# Access Compliance Report

## Public Rights-of-Way (Curb Ramps)

Intersection ID: N/A	Main Street: TWITTER_LN	Cross Street: ROCKY_RIVER_RD	Location: NW
ADA ID: 422AA6EDD370	Ramp Type: Para	Initial Pass/Fail: Fail	Overall Compliance: No
		Severity Score: 12.5

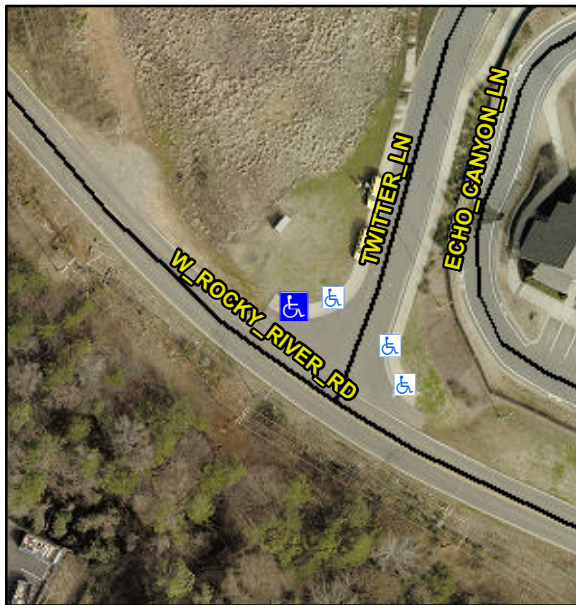
**RT RP < 5%**

**R304.3.2**

**Remove & Replace Entire Ramp.**
